Entergy Operations, Inc.
1340 Echelon Parkway
Jackson, Mississippi 39213-8298

G3NO-2008-00001

DOCKET NO.: 52-024

SUBJECT: Responses to NRC Requests for Additional Information on
Environmental Report (GG3 COLA)

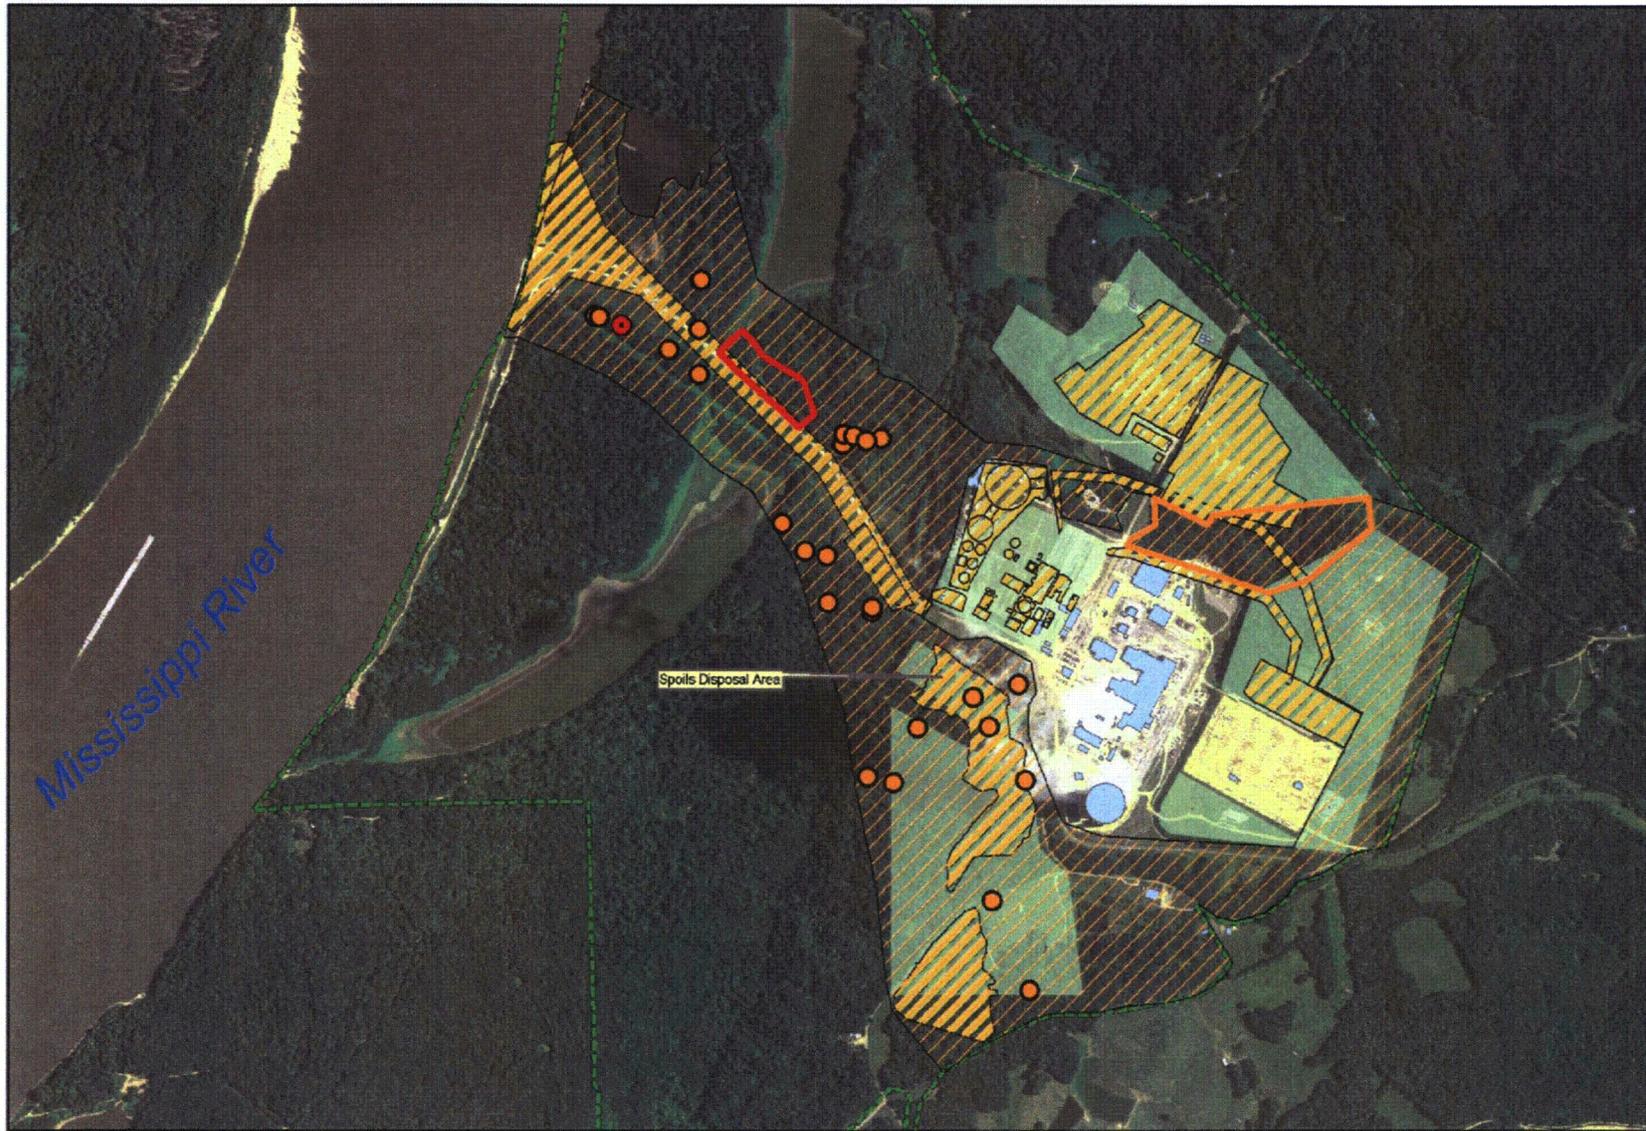
Item	ESRP/ER Section	RAI	Supporting information
TERRESTRIAL ECOLOGY			
5	ESRP Section 2.4.1	Provide a figure that depicts the areas surveyed for the five State-listed plants and Louisiana black bear cavity trees and related sign. Provide a figure that depicts the spatial extent of the three wetland types that would be affected by the proposed water pipeline corridor under its preliminary design.	<p>The September 10-13, 2006 reconnaissance report states that plant surveys were conducted in the proposed water pipeline corridor, the onsite transmission line corridor connecting the new power block to the existing switchyard, and the "South Woods." The April 22-27, 2007 reconnaissance report states that the plant surveys were conducted in the fabrication and batch plant area, construction warehouse area, construction laydown area (near the old ball field), and the cooling tower area; however, these are not mentioned in ER section 2.4.1.2.1 (State-listed Plants). The spatial extent of these areas is unclear. Provide a figure depicting all the areas surveyed for plants. For any large areas (e.g., South Woods) also provide survey locations in the figure.</p> <p>The December 10-14 2006 reconnaissance report states that Louisiana black bear surveys were conducted on both sides of the heavy haul road and in the South Woods. The April 22-27 2007 reconnaissance report states that Louisiana black bear surveys were conducted in the area immediately adjacent to the existing switchyard and in the South Woods. The spatial extent of these areas is unclear. Provide a figure depicting all the areas surveyed for Louisiana black bear cavity trees and related sign.</p> <p>The Wetland and other Potentially Jurisdictional Waterbody Identification and Delineation from June 2007 discusses 17.5 acres of wetlands that would be disturbed by the proposed water pipeline corridor under its preliminary design. Provide a figure depicting the 4.2 ac of palustrine, emergent, persistent, seasonally flooded (PEM1C) wetlands; 10.1 ac of palustrine, forested, broad-leaved deciduous, seasonally flooded (PFO1C) wetlands; and 3.2 ac of palustrine, shrub-scrub, broad-leaved deciduous, seasonally flooded (PSS1C) wetlands.</p>

- ER RAI 5, Figure 1, included in this attachment, which indicates areas on the Grand Gulf site that were surveyed for Louisiana black bear. Thirty-three trees of diameter at breast height (DBH) sufficiently large to qualify as a candidate tree were identified during the Louisiana black bear habitat survey. Nine were found in the South Woods in the upland, three were found in the mixed hardwood-pine stand to the north-northwest of the new switchyard in the upland, thirteen were found south of the heavy haul road, seven were found north of the road in the bottomland and one candidate tree was located east of the South Woods. Coordinates were recorded for all candidate trees, except the three near the new switchyard.
